**163rd Street (Old Y Highway) -
M-58 Highway to Markey Parkway
City project No. 442-5411-495-7112
Federal project No. STP-3400 (421)**

ADDENDUM NO. 3

**April 13, 2011
Addendum No. 3**

AMERICAN PUBLIC WORKS ASSOCIATION	
APWA	KANSAS CITY METROPOLITAN CHAPTER
MANHOLE DETAILS	STANDARD DRAWING NUMBER MH - 1
	ADOPTED: APRIL 17, 1996

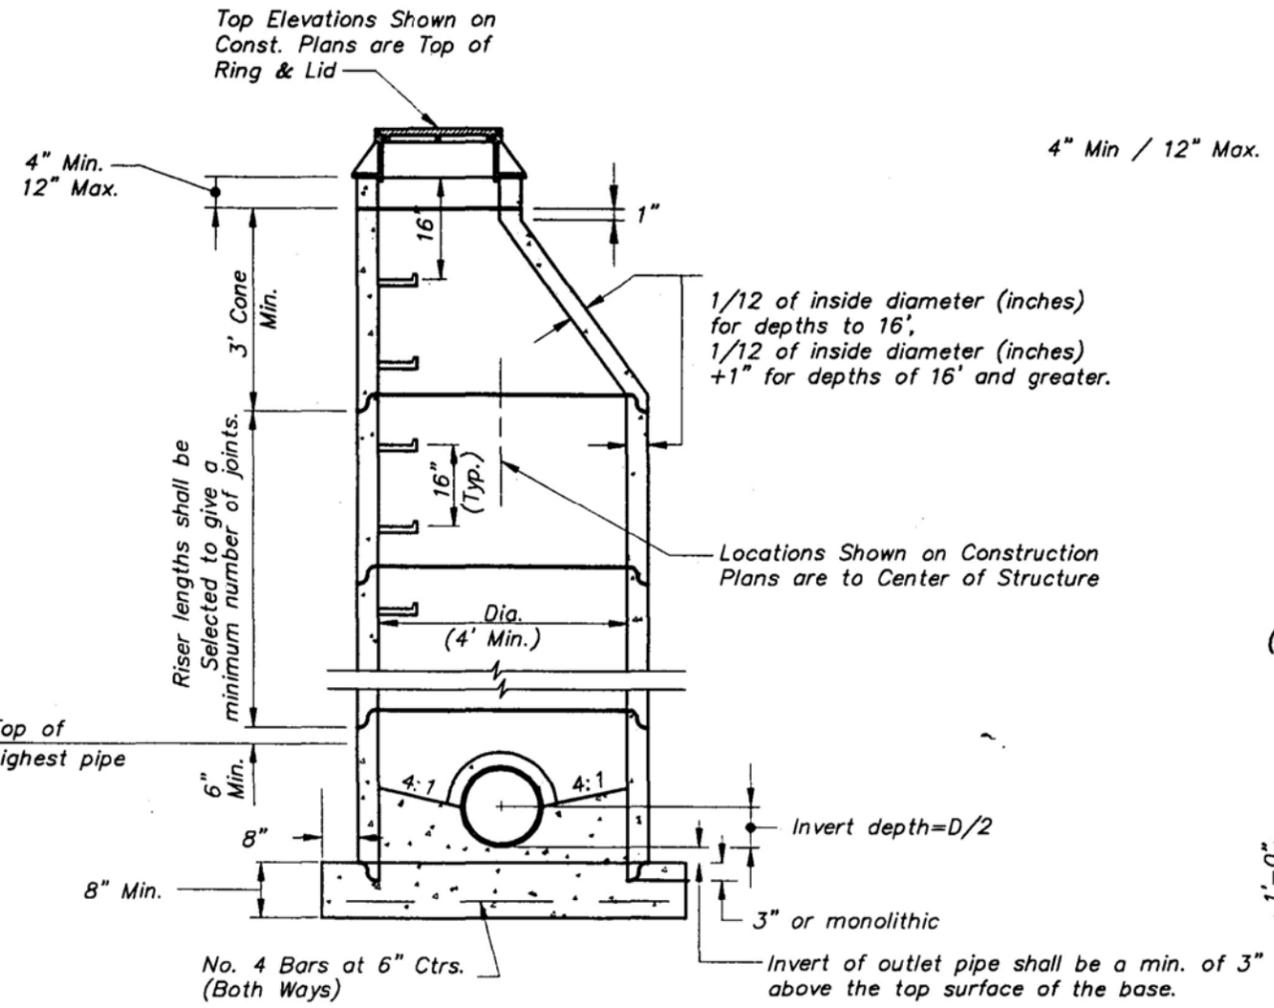
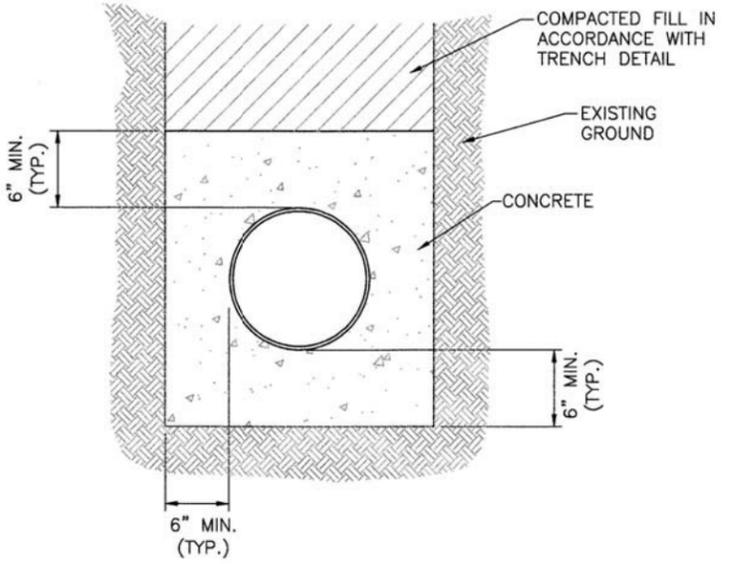
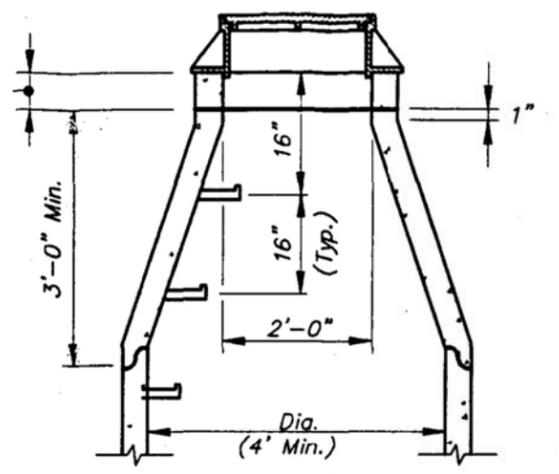
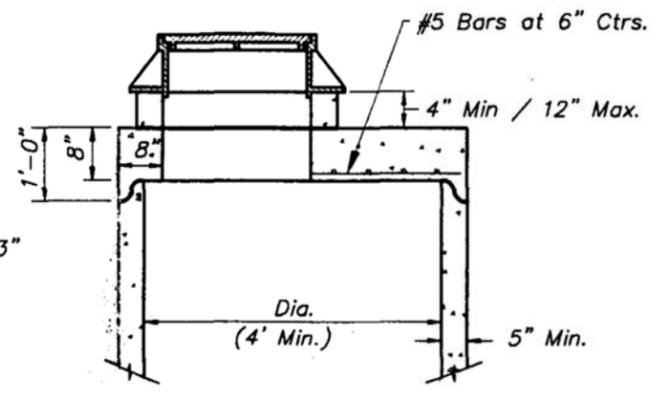
- Sheet 2 Revised the Bid Item Name and Quantity for Bid Item #76.
- Sheet 2 Added Bid Item #158.
- Sheets 30 Revise General Notes #12 as follows:

NO.	DATE	REVISIONS	APPD.
1	4/13/91	Addendum #3 - Revise Note 12	
2			
3			
4

12" Ductile Iron Pipe (Sanitary) shall be class 52 epoxy lined "(Super Coat)" ductile iron pipe. Ductile Iron Pipe (Sanitary) shall be wrapped with polyethylene. Polyethylene to be subsidiary to "12" Ductile Iron Pipe (Sanitary)".

- No direct payment for shaping floor or connecting pipes as shown on plans.
- Ring & Cover to be Heavy Duty ring & cover as shown on Page 29.
- 12" Ductile Iron Pipe (Sanitary) shall be class 52 epoxy lined "Super Coat" ductile iron pipe. Ductile Iron Pipe (Sanitary) shall be wrapped with polyethylene. Polyethylene to be Subsidiary to "12" Ductile Iron Pipe (Sanitary)".
